RECEIPT DATE: 11/15/16**ONSITE SEWAGE DISPOSAL SYSTEM**P 559841APPROVAL DATE: 3/1/17 SEC**PERMIT:****CONSTRUCTION**

PROPERTY ADDRESS: 12504 Triadelphia RoadSUBDIVISION: The Woods at TriadelphiaLOT: 3TAX ID: 03-352269CONTRACTOR: P H Dymond

FSH ASSOCIATES — TRANSMITTAL OF MATERIALS

From: Oswald, Hank [<mailto:hoswald@howardcountymd.gov>]
Sent: Tuesday, February 09, 2016 8:36 AM
To: Zach Fisch <zfisch@FSHERI.COM>
Subject: BAT Plan_12504 Triadelphia Road

Size Pump For

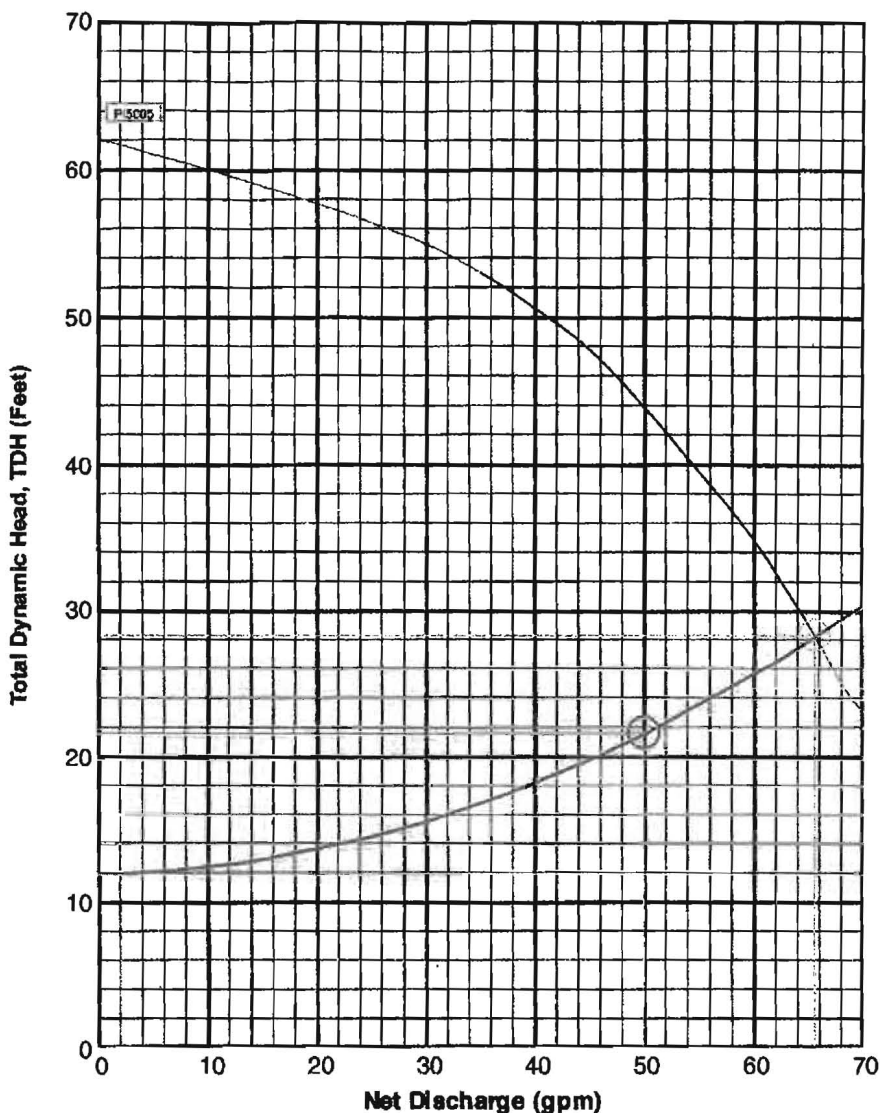
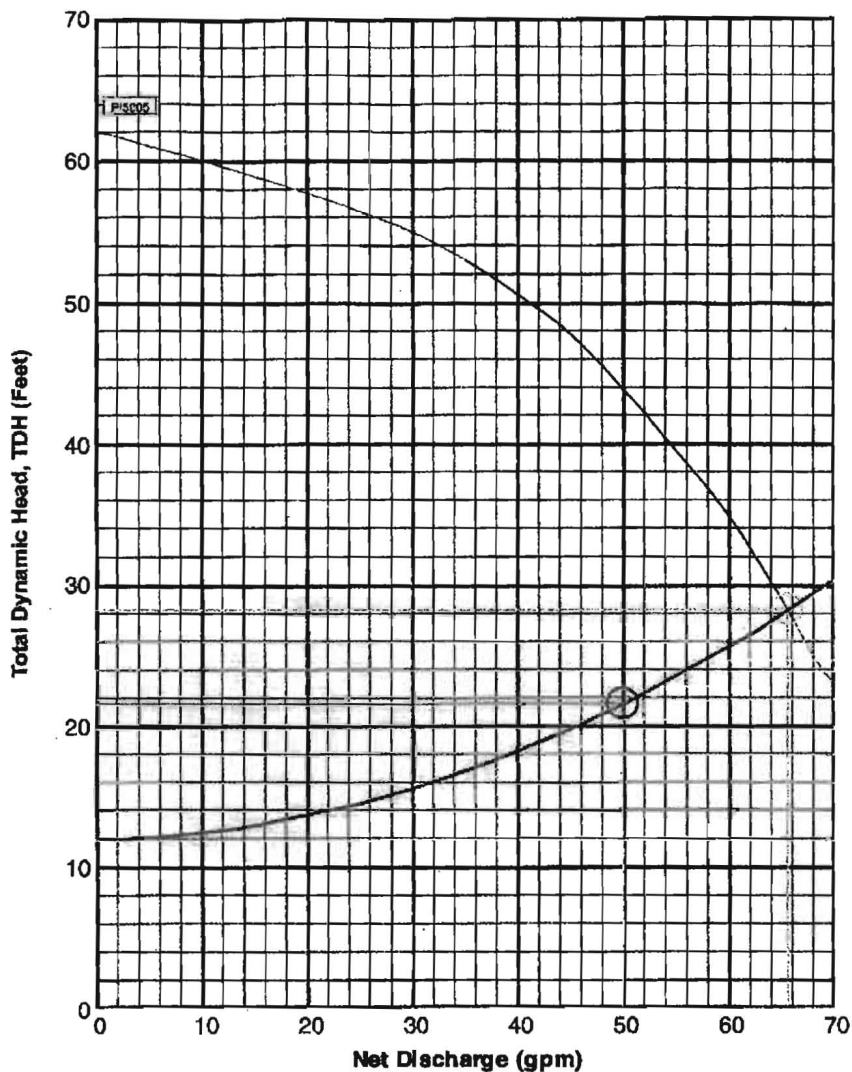
Typically, we'd like to see the pump runtime right around 2 minutes at 40 – 50 gpm.

I checked with Jeff on this. The pump unit configuration must be presented on the plan as well as in the profile. The pump unit must be capable of handling 24 hour of emergency storage. The pump make and model along with the pump curve etc. should also be included.

Please forward you the pump curve and head loss calculations for this pump/BAT plan. In addition, what is the run time and gpm for this system?

Based on the information provided, it appears that the real output will be where the 2 lines intersect (approximately 66 gallons/minute). This would still be okay since its only pumping up to a d-box and gravity fed from there.

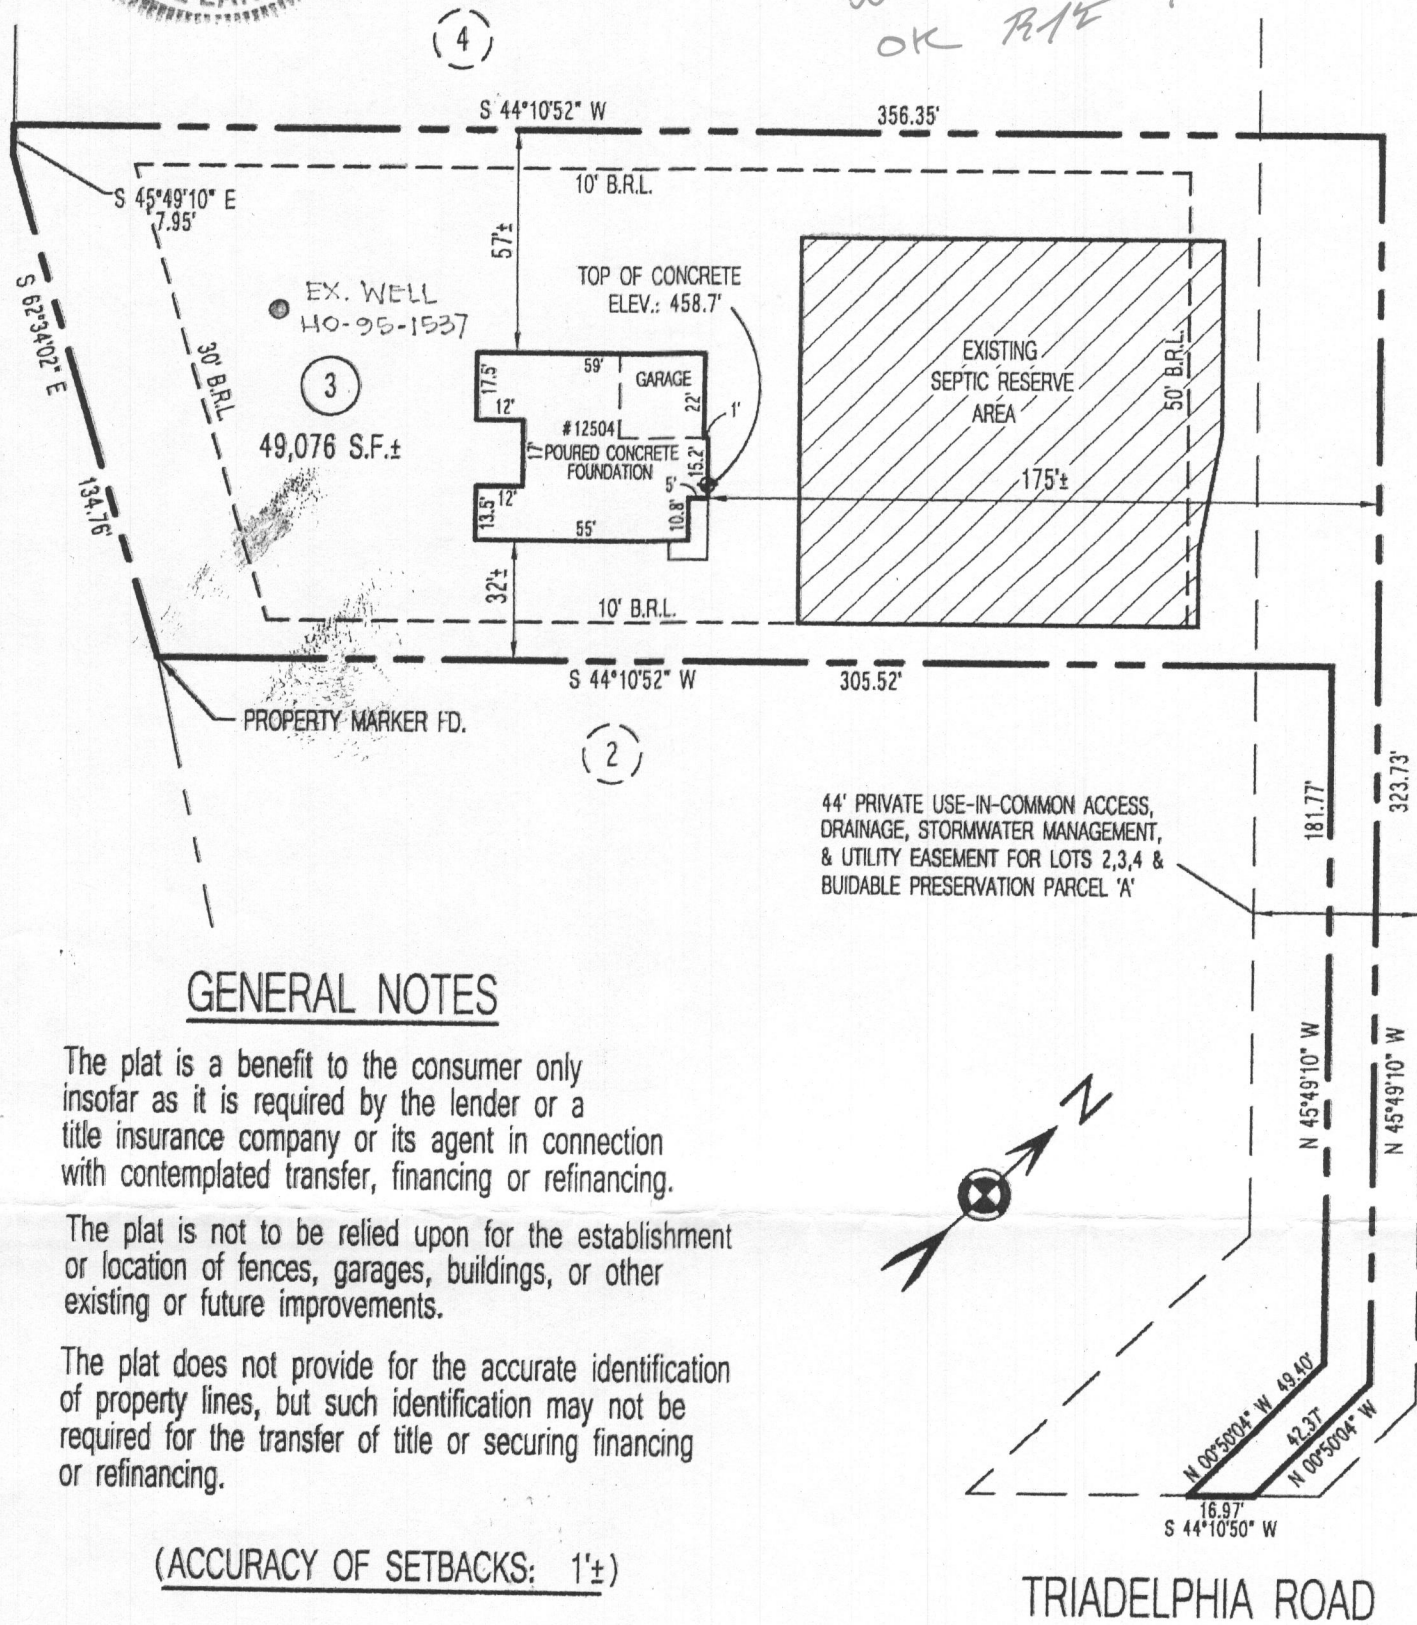
We're doing the septic install with Paul Dymond at 12504 Triadelphia Road. Paul would like to install a check valve in the line coming out of the pump tank. Would you be able to confirm that the pump will be adequate with the increased friction loss of a check valve?

The 2" pressure line he installed is HDPE, 250psi SDR 9 line. I'm used to seeing 2" PVC for force mains with couplings and bends and didn't know if this changed the friction loss at all.
